FCL COMPONENTS AMERICA, INC.

Ref. No.: FCAI-RLPCN-20260908-01

SUBJECT : FTR-P3 Relay Bobbin/Base fixing method change

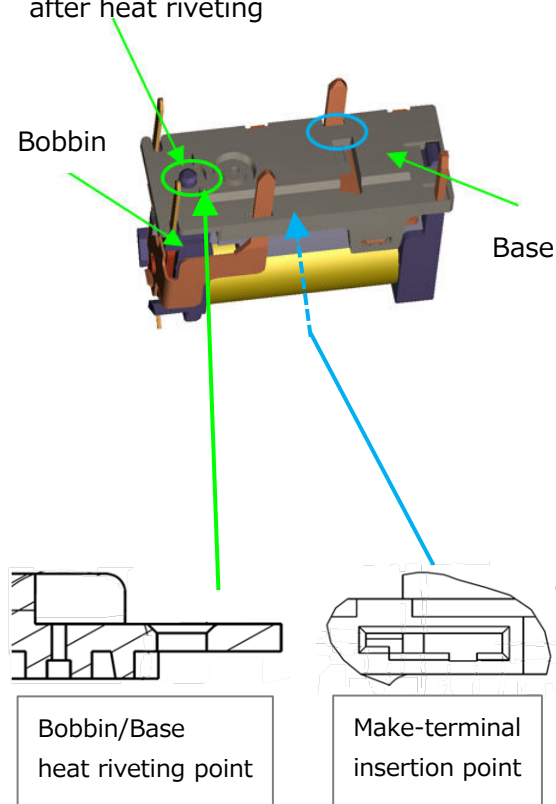
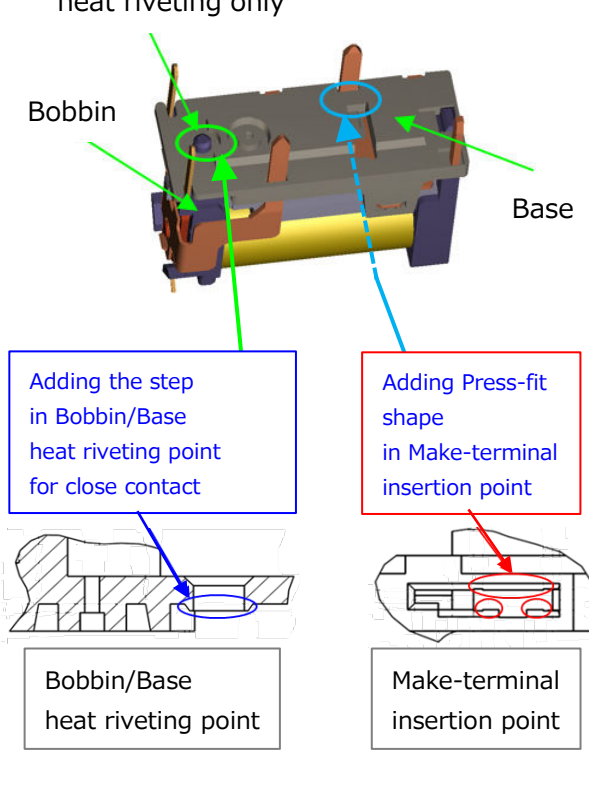
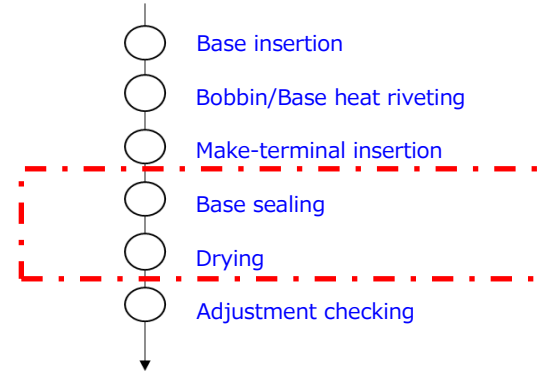
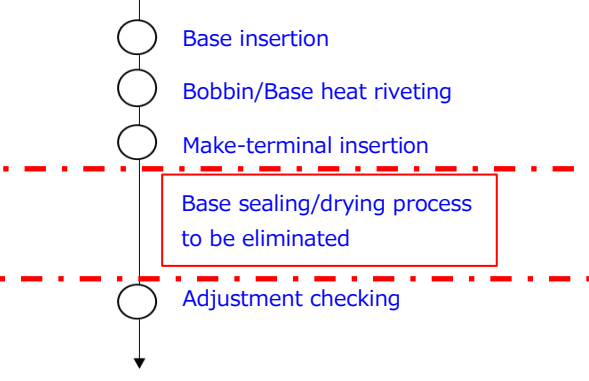
Bobbin/Base fixing method is going to be changed into only heat riveting.

Base sealing/drying process is going to be eliminated.

This change enables to eliminate adhesion of sealing material inside aluminum magazine being used in Base sealing/drying process and the possibility of secondary accident (abrasion of resin material, sealing material coming off) due to that.

Base shape changes are also going to be implemented for purpose of improving close contact on heat riveting, countermeasure for abrasion of resin material.

Current	After changed
Change detail	Fixing Bobbin and Base with adhesive after heat riveting  Bobbin Base Bobbin/Base heat riveting point Make-terminal insertion point	Fixing Bobbin and Base by heat riveting only  Bobbin Base Adding the step in Bobbin/Base heat riveting point for close contact Adding Press-fit shape in Make-terminal insertion point Bobbin/Base heat riveting point Make-terminal insertion point
Manu-facturing process	 Base insertion Bobbin/Base heat riveting Make-terminal insertion Base sealing Drying Adjustment checking Base sealing/drying process included	 Base insertion Bobbin/Base heat riveting Make-terminal insertion Base sealing/drying process to be eliminated Adjustment checking Base sealing/drying process to be eliminated
